■INTAKE AND EXHAUST SYSTEM

225EG06

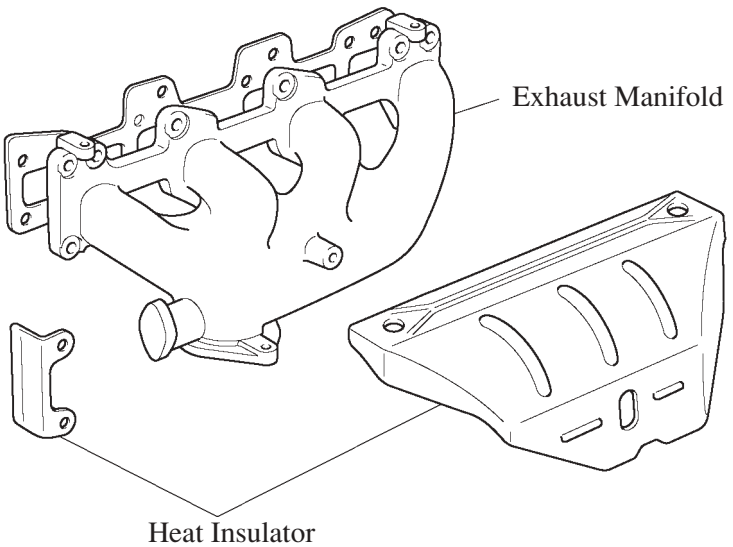
The intake manifold shape has been changed to install the LPG carburetor and ISCV.
